[Docket No. FAA-2012-0415; Directorate Identifier 2008-SW-065-AD; Amendment 39-17865; AD 2014-12-04]

**Airworthiness Directives; Bell Helicopter Textron, Inc. (BHTI) Helicopters**

**ACTION:** Final rule.

Figure 1 to Paragraphs (f)(2)(ii) and (f)(4)(ii)  
Inspection of Main Rotor Hub Grip Tangs

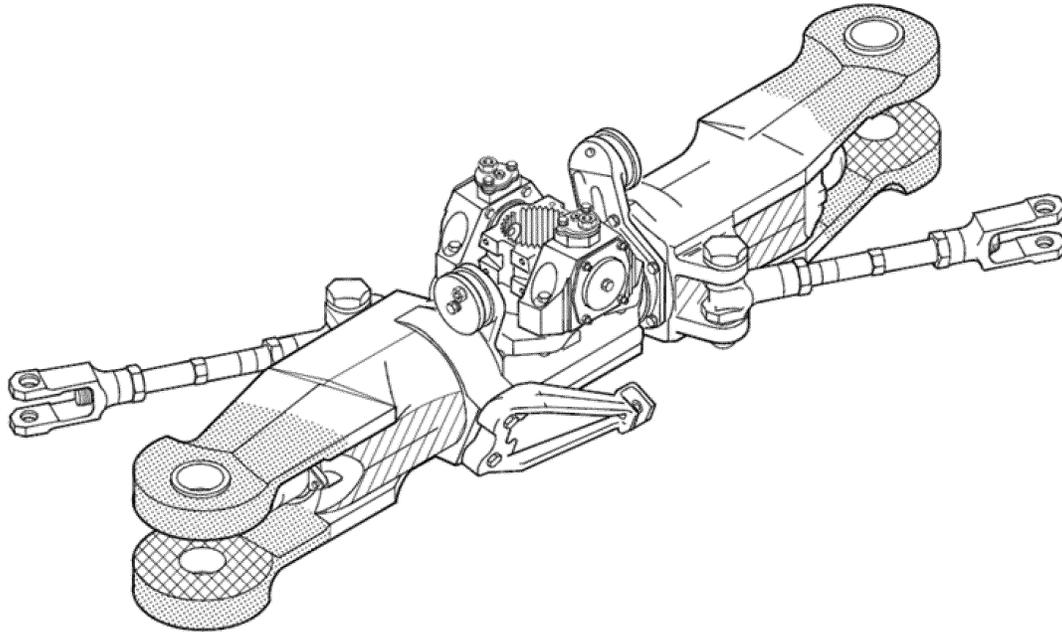
- (i) Clean the exposed surfaces of the upper and lower tangs of each grip with denatured alcohol, and wipe dry.
- (ii) Using a 10-power or higher magnifying glass, visually inspect the exposed surfaces of the upper and lower tangs of each grip for a crack. Pay particular attention to the lower surface of each lower grip tang from the main rotor blade bolt-bushing flange to the leading and trailing edge of each grip tang as depicted in Figure 1 to Paragraphs (f)(2)(i) and (f)(4)(ii) of this AD.

(ii) Inspect each grip buffer pad on the inner surfaces of each grip tang for delamination as depicted in Figure 1 to Paragraphs (f)(2)(ii) and (f)(4)(ii) of this AD. If there is any delamination, remove the buffer pad and inspect the grip surface for corrosion or other damage.
